**MS-17-00554:** A Minor Subdivision/Replat for Casey's Subdivision, located at 1703 and 1711 W. 6<sup>th</sup> Street to consolidate two platted lots into a single lot for redevelopment. Submitted by Casey's Retail Company on behalf of Harold Shephard and Marla J. Webster and James and Brenda Vantuyl, property owners of record.

**ADMINISTRATIVE DETERMINATION:** The Planning Director approves the above-described Minor Subdivision subject to the City Commission approval of acceptance of vacation of a cross access easement as shown on the attached drawing subject to the following conditions:

Figure 4: Proposed Casey's Subdivision

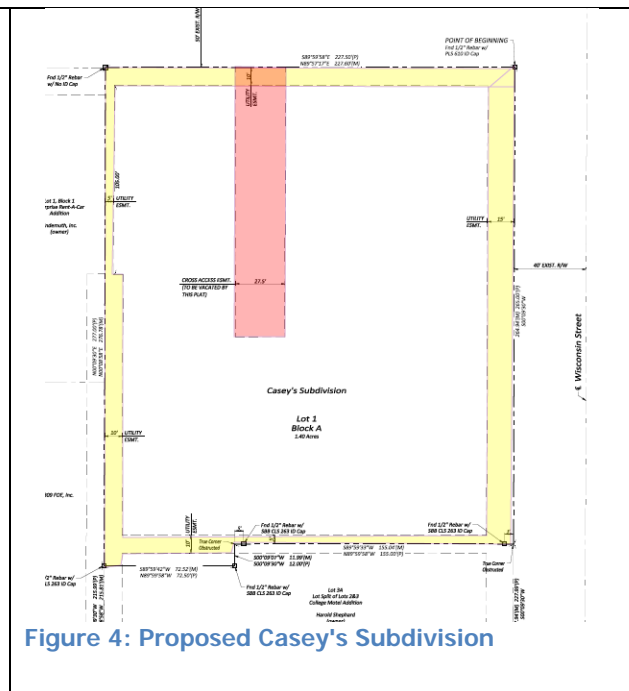
1. Submission and approval of public improvement plans
2. Provision of a Master Street Tree Plan for recording with the Douglas County Register of Deeds Office.
  - a. Provision of a revised Minor Subdivision drawing to include General Note 8; note the date the Planning Commission approved the variance for the right-of-way width along W. 6<sup>th</sup> Street, October 25, 2017.

The existing cross access easement provided with the original property subdivision shared access between the two lots for access to W. 6<sup>th</sup> Street. The consolidation of the property into a single lot and the intended redevelopment make this easement obsolete. The applicant proposes to vacate the easement as shown on the drawing. Vacation of this easement will facilitate the redevelopment of the site. City Commission approval of the proposed easement vacation is required. Approval of this Minor Subdivision is subject to consideration and action by the City Commission to vacate the shared access easement.

**Figure 6: Proposed 6<sup>th</sup> Street Access**

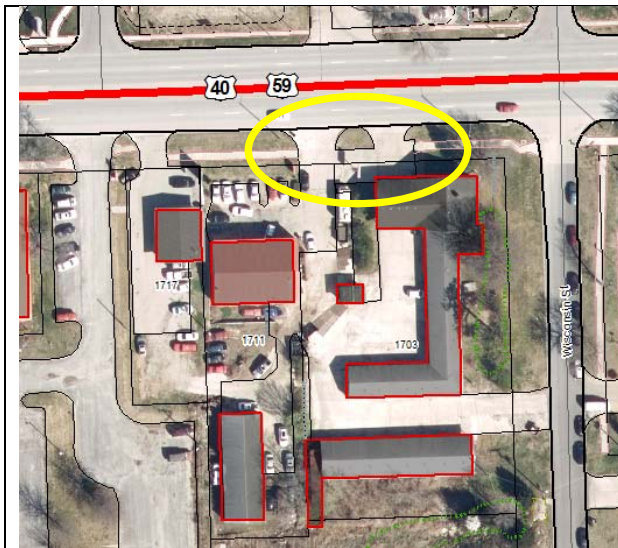
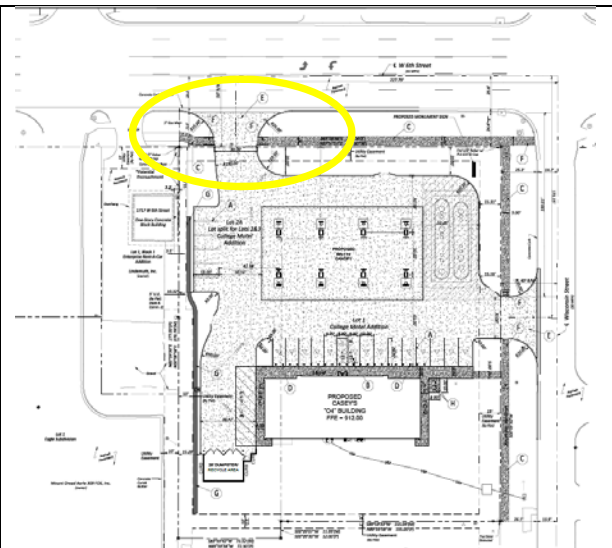
**Interior Access and Circulation:** Access to the site is currently provided from both of the adjacent streets. Access is proposed to be revised by closing the two existing side by side driveways to W. 6<sup>th</sup> Street and constructing a new curb cut at the west end of the property farther away from the intersection. The access drive to Wisconsin Street would also be relocated farther to the north, closer to the intersection as shown on the proposed site plan. These access points reflect the operational needs of the proposed use (gas and convenience store) as well as a design to locate development closer to W. 6<sup>th</sup> Street providing the greatest buffer area between the commercial uses and the residential uses to the south.

The traffic study noted specific improvement that must be provided for this development. Both a traffic signal and a turn lane are required. Both of these improvements can be constructed within the existing right-of-way. Development of the site will require public improvement plans. The Minor Subdivision cannot be recorded until public improvement plans have been submitted, reviewed and approved, and that a guarantee for their construction is provided.
